FALCON SERVICE BULLETIN

FALCON 900

No 411-R1

**FUSELAGE
APU AIR INTAKE
PROTECTION AGAINST FLUID INGESTION
DURING DE-ICING PROCEDURE**

Gutter for APU air intake grid: All A/C
- FIGURE 1 -

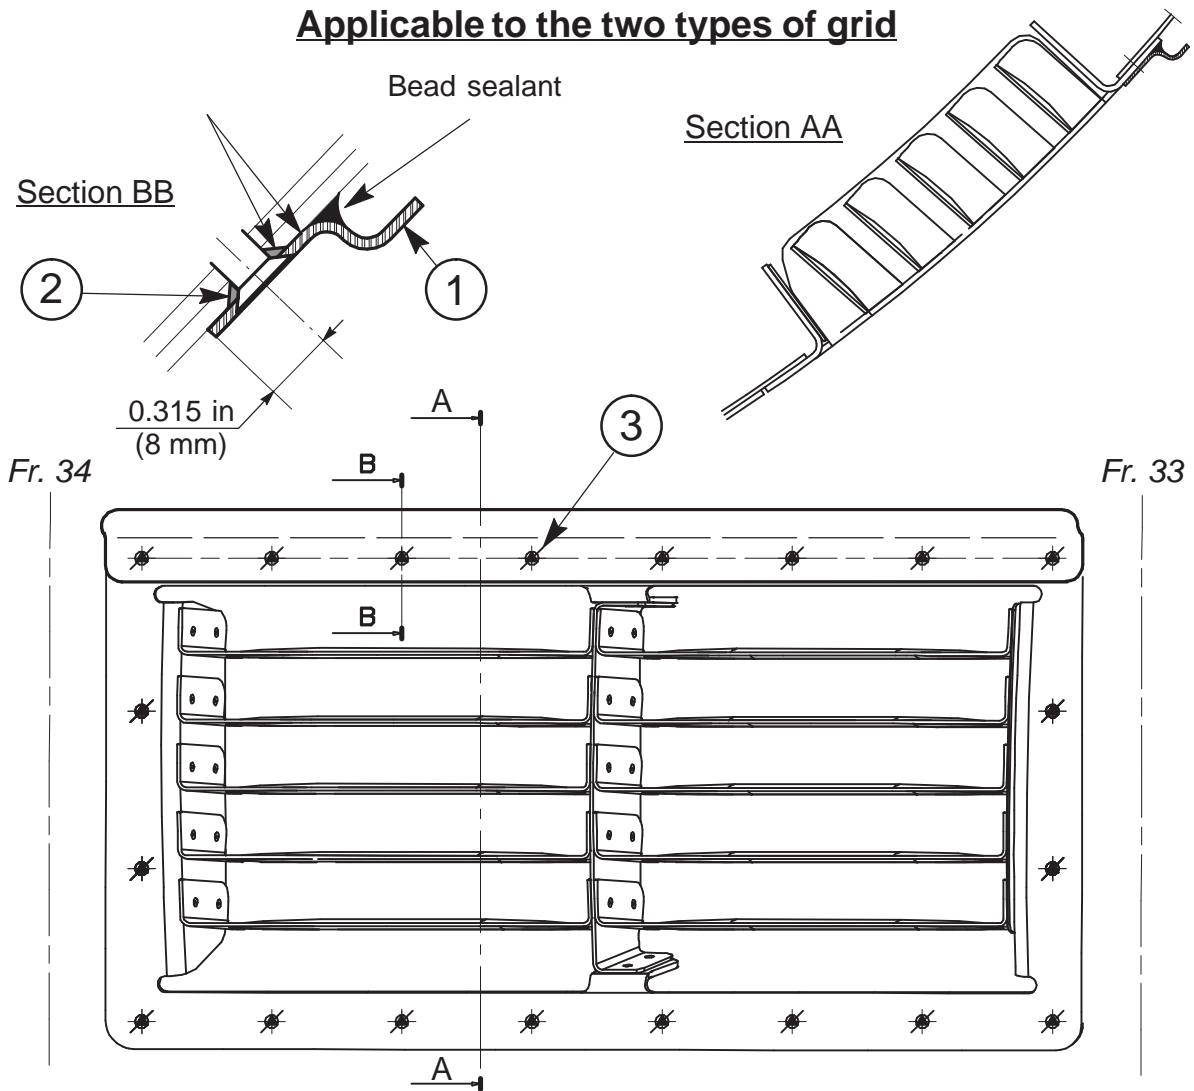
B . INSTALLATION OF THE GUTTER ON THE APU AIR INTAKE (see figure 1)

- (1) Remove the APU air intake grid (see IPC chap. 49-10-00, fig. 01, item 185) taking care not to lose the washers (item 205) if installed.
- (2) Rub the setting surface of the gutter on the APU air intake grid and clean.

- (3) Position the gutter (item 1) on the frame of the grid.
- (4) Counterdrill the eight holes in the gutter to dia. 0.1 in (2.5 mm).
- (5) Enlarge the holes in the gutter to dia. 0.2 in (5.1 mm).

- (6) Set up the tapered washers (item 2) in the countersinking of the eight upper holes of the grid and old the gutter against the APU air intake grid.

- (7) Countersink the holes of the gutter for screws (item 3).
- (8) Sand the countersinking of the eight upper holes of the APU air intake grid.
- (9) Use alodine to protect the countersinking.

- (10) Bond the tapered washers (item 2) in the countersinking of the eight upper holes of the grid using interlaying sealant.
- (11) Install the grid (and the washers item 205 if installed) using only the screws removed for the lower and the side holes.

- (12) Install the gutter with interlaying sealant using the new screws (item 3). Apply a bead of sealant on the gutter.

Gutter for pylon trailing edge without angle section: A/C S/N 1 through 165

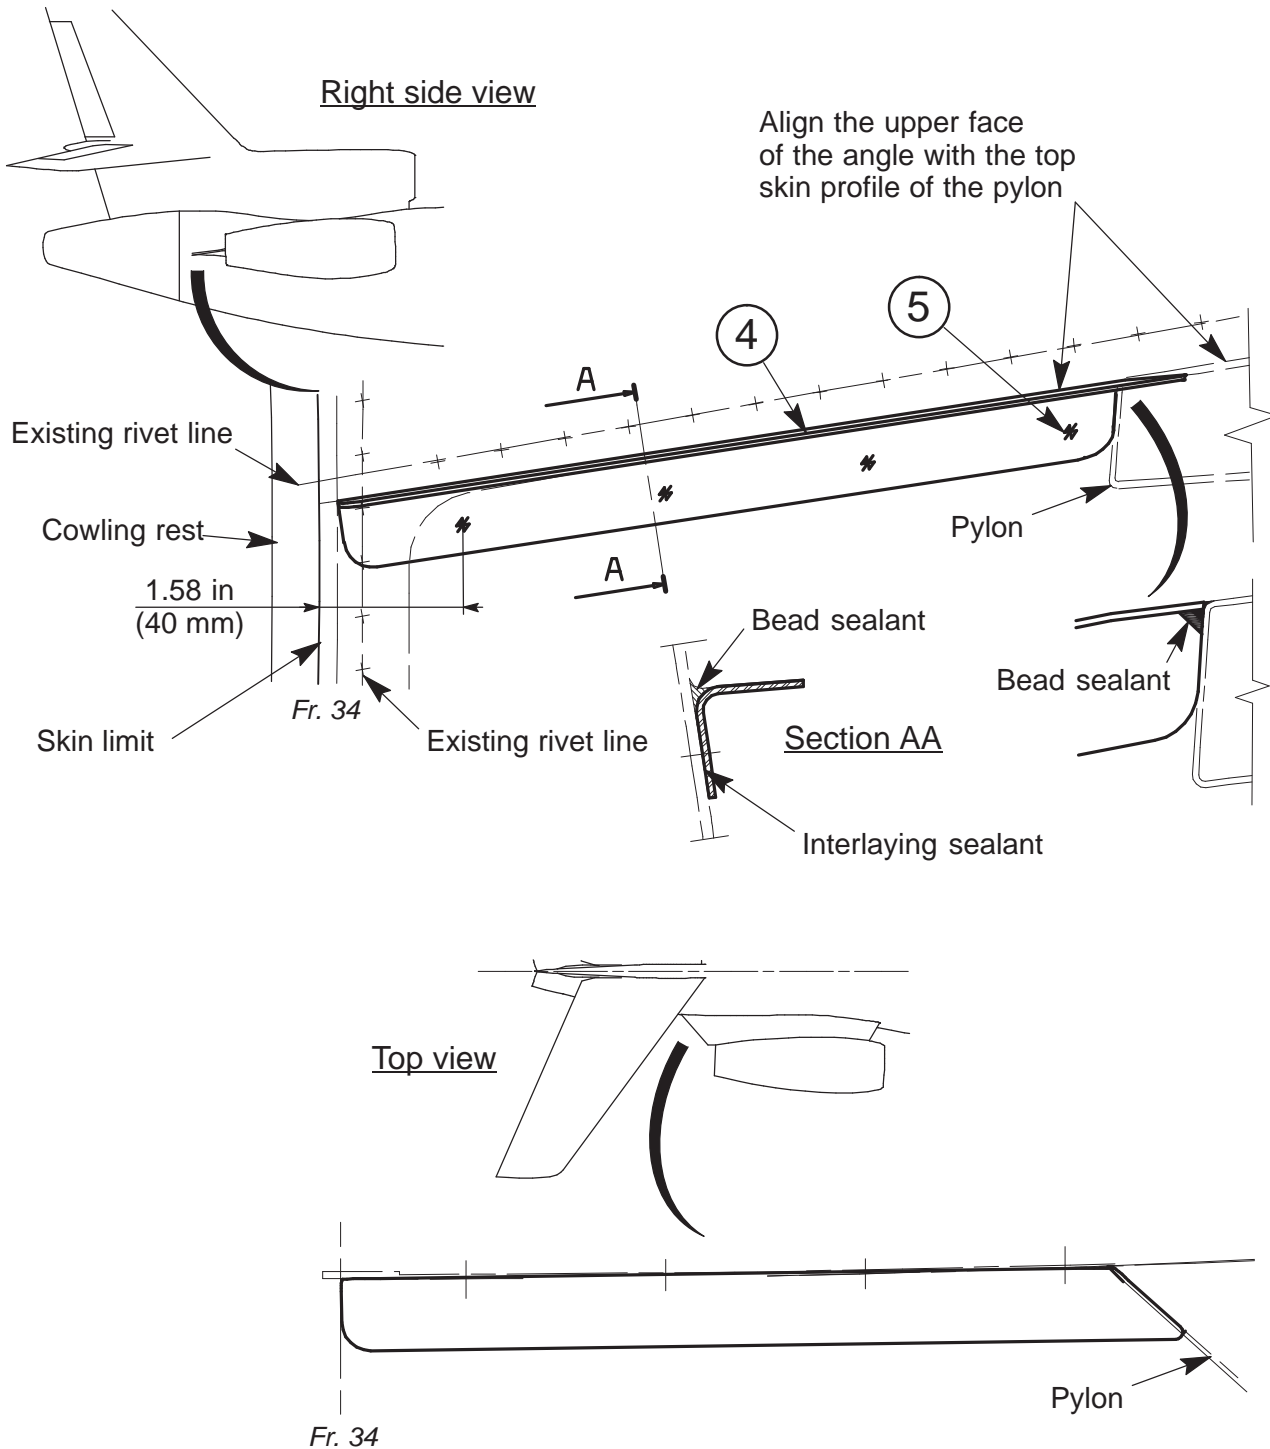
C . INSTALLATION OF THE ANGLE BEHIND THE TRAILING EDGE OF THE RH PYLON FOR AIRCRAFT S/N 1 THROUGH 165 (see figure 2)

- (1) Scribe a line protracting the profile of the pylon trailing edge upper surface on the fuselage.
- (2) Position the angle in accordance with the line and counterdrill the fuselage to dia. 0.1 in (2.5 mm).
- (3) Enlarge the holes in the angle and the fuselage to dia. 0.125 in (3.3 mm).
- (4) Draw the outline of the angle on the fuselage.
- (5) Remove the angle.
- (6) Countersink the holes in the angle for rivets (item 5).
- (7) Rub the setting surface of the angle on the fuselage and clean.
- (8) Install the angle with interlaying sealant, using rivets (item 5).
- (9) Apply the bead of sealant between angle and fuselage, and angle and pylon.

Gutter for pylon trailing edge with angle section: A/C 166 and subsequent
- FIGURE 3 -

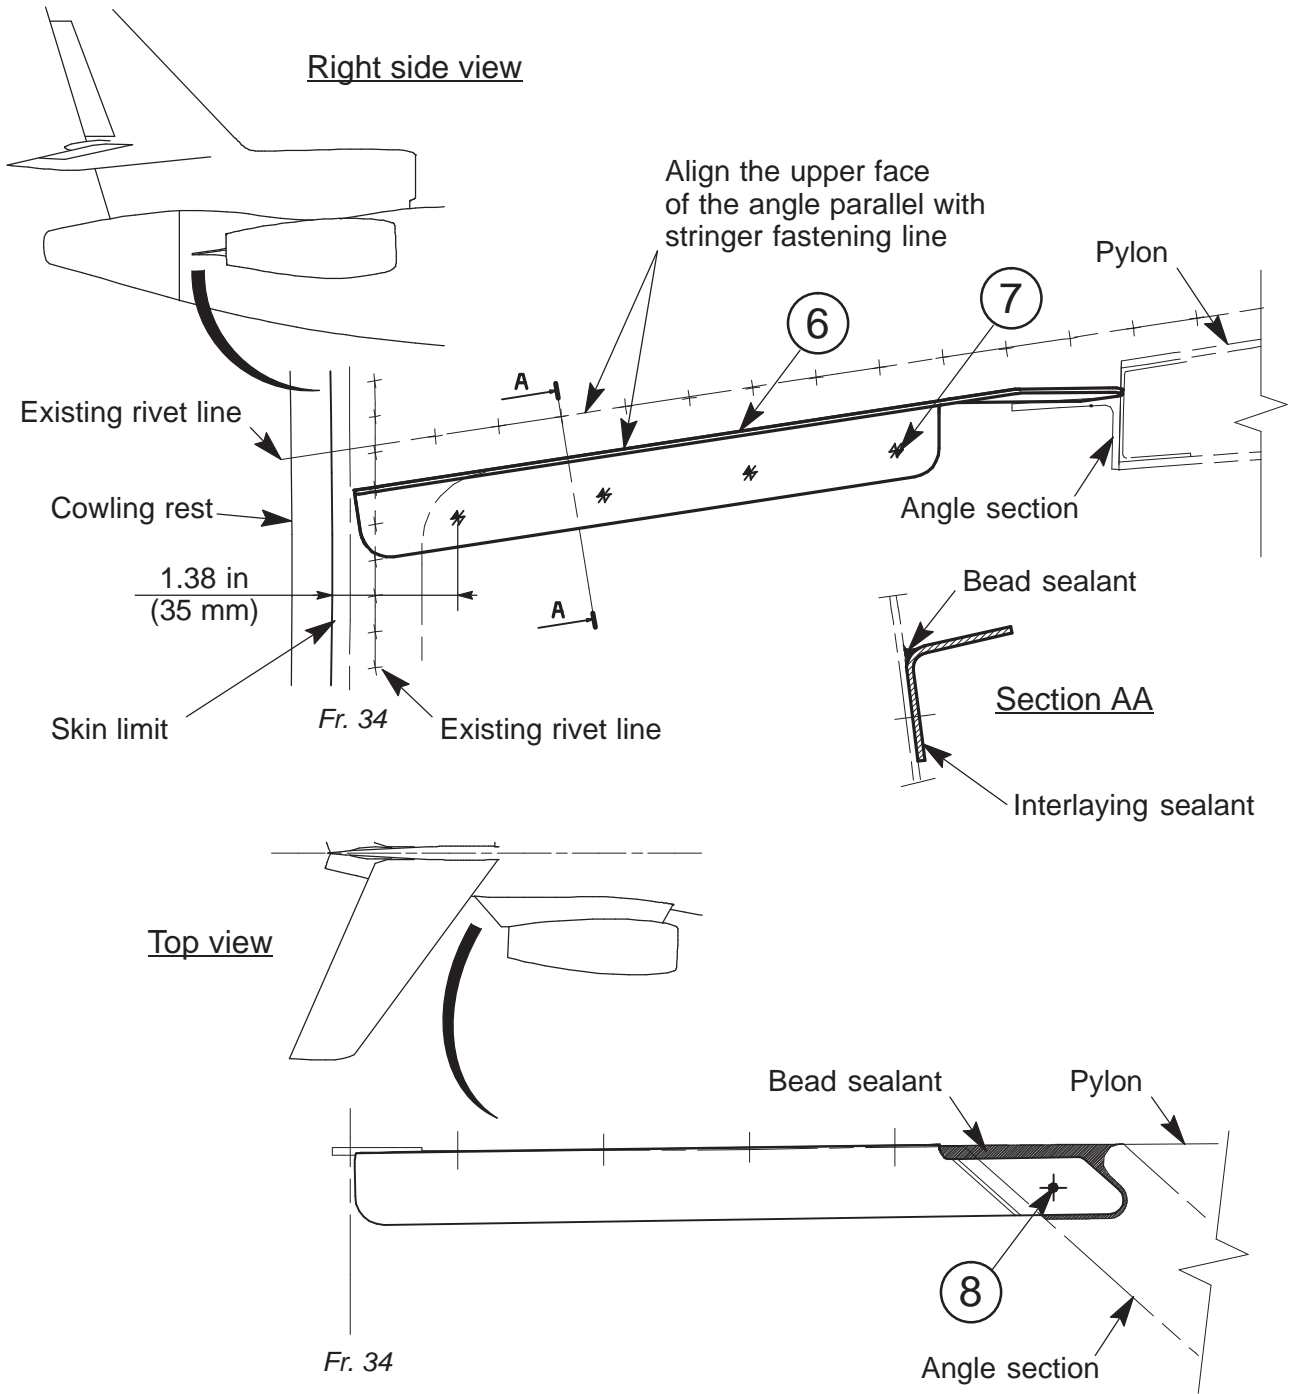
D . INSTALLATION OF THE ANGLE BEHIND THE TRAILING EDGE OF THE RH PYLON FOR AIRCRAFT S/N 166 AND SUBSEQUENT (see figure 3)

- (1) Position the angle (item 6) against the angle section of the pylon.
- (2) Orientate the angle (item 6) with the upper face parallel with the stringer fastening line.

- (3) Counterdrill the fuselage in accordance with the angle to dia. 0.1 in (2.5 mm). Pin the angle.
- (4) Counterdrill the pylon angle section in accordance with the angle to dia. 0.1 in (2.5 mm).

- (5) Enlarge the holes in the angle and the fuselage to dia. 0.125 in (3.3 mm).
- (6) Enlarge the holes in the angle and the pylon angle section to dia. 0.13 in (3.3 mm).

- (7) Draw the outline of the angle on the fuselage and the pylon angle section.
- (8) Remove the angle.
- (9) Countersink the holes in the angle for rivets (item 7) on the fuselage side only.

- (10) Rub the setting surface of the angle on the fuselage and the pylon angle section and clean.
- (11) Install the angle with interlaying sealant, using rivets (item 7) and (item 8).

- (12) Apply the bead of sealant between angle and fuselage and angle and pylon.
